HYUNDAI
Technical Service Bulletin

GROUP CAMPAIGN	NUMBER 20-01-004H
DATE FEBRUARY 2020	MODEL(S) APPLICABLE VEHICLES BELOW

SUBJECT: THETA GDI ENGINE DTC P1326 - ENGINE INSPECTION / REPLACEMENT (SERVICE CAMPAIGN T3G)

This TSB supersedes TSB# 19-01-006H-4 to revise the Service Procedure.

Exhaust Stud Position Relocation Information

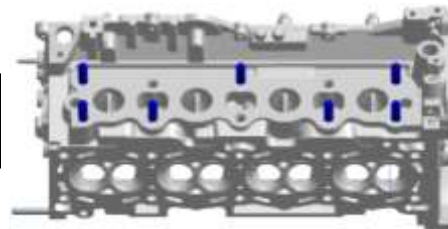
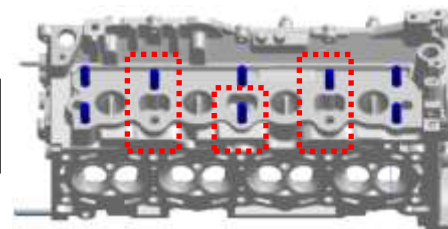
4. **For 2.4L with ULEV / FED emissions only**
 2.4L replacement engines are produced with the exhaust manifold studs configured for SULEV / CAL emissions package.

Two exhaust studs must be relocated on the new engine and 1 exhaust stud must be transferred from the old engine.

- Use a commercially available stud removal tool or use the double-nut technique to complete this step.
